# SUBMISSION TO THE DRAFT AEROTROPOLIS PRECINCT PLAN

Prepared for  
**BHL GROUP**  
March 2021

Figure 19 - Undisturbed Soil Cross Section

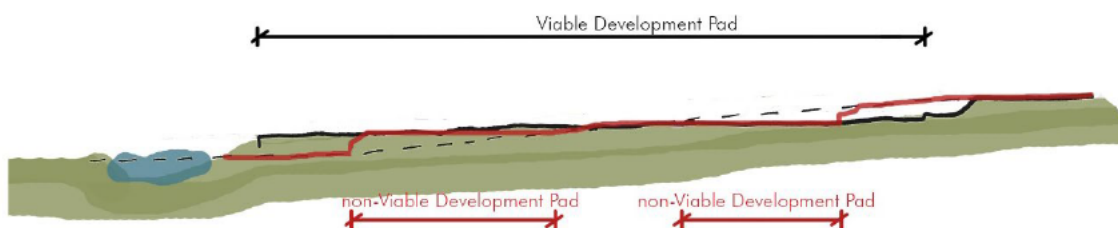
AT&L have reviewed the requirements for undisturbed soil and make the following comments:

- Maintaining an undisturbed soil network of 17.6m wide along road edges produces reduced building pad widths which are below industry standard, unfeasible and inefficient for employment land uses (shown in red in **Figure 19**).
- Conversely, maintaining this network along existing riparian corridors provides not only an interconnected soil network and biodiversity/blue green infrastructure corridors it allows for a more uniform and viable production of development pads that provides efficiency (shown in black above).

Figure 22 - 0-30+ Years, Development & Land Use Evolution

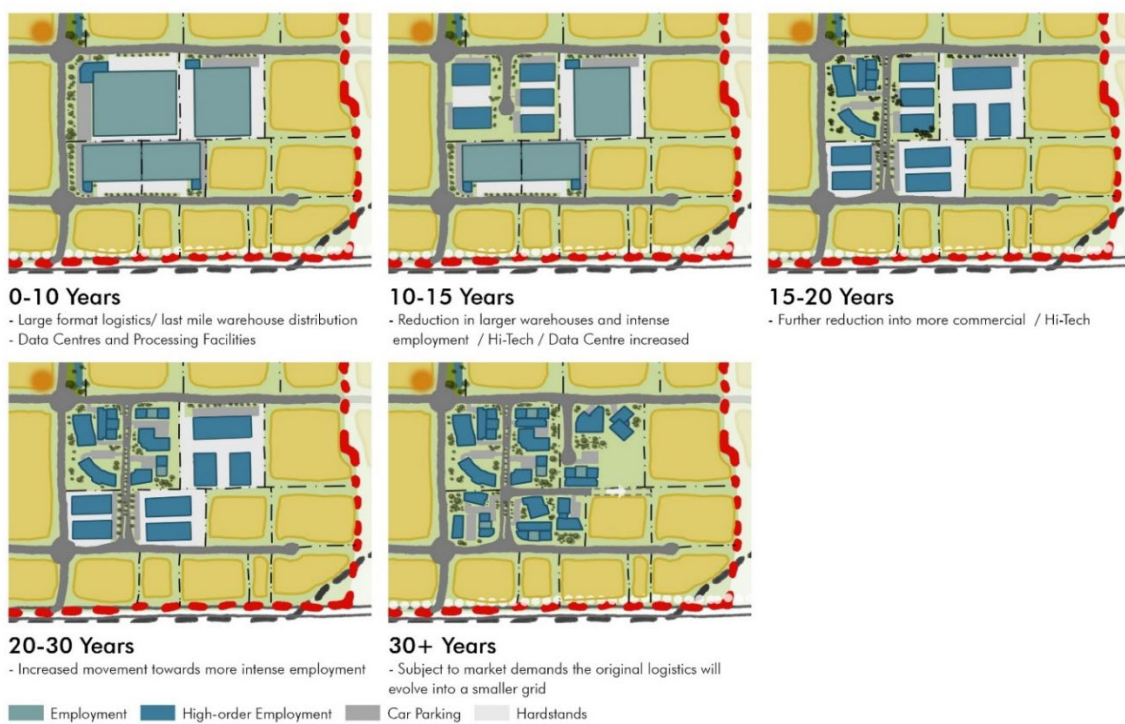
- The draft Precinct Plan should reflect how development controls can facilitate investment in the short term, while enabling block patterns to be subdivided over time with the evolution of the precinct to eventually create the desired fine grained urban grid as land uses intensify over time. This approach is illustrated in **Figure 22** below.

Figure 23 - Building Height Case Studies

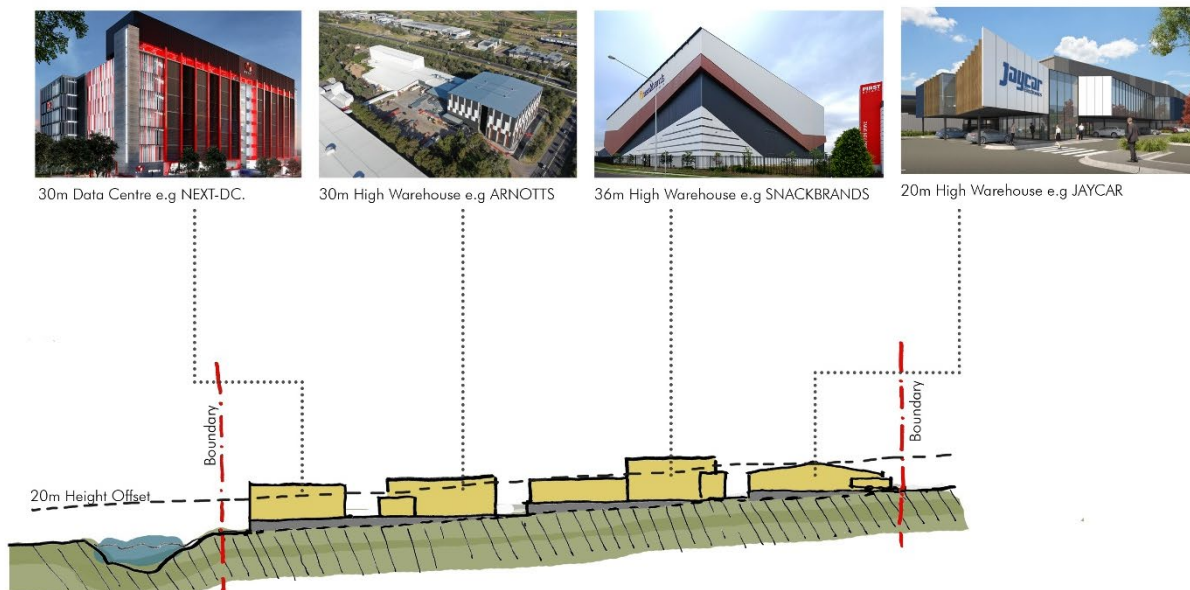
- The 20m height limit is overly restrictive and demonstrates a significant lack of understanding of current market trends and demand for high bay sheds and other innovative building typologies as illustrated in **Figure 23**.

- A more appropriate mechanism to control building heights can be provided by the OLS for WSA which will effectively control building heights closer to WSA and allow more flexibility for end users (refer **Figure 24**). An example of this approach can be seen around Sydney Kingsford Smith Airport and more specifically, the IKEA development in Tempe.
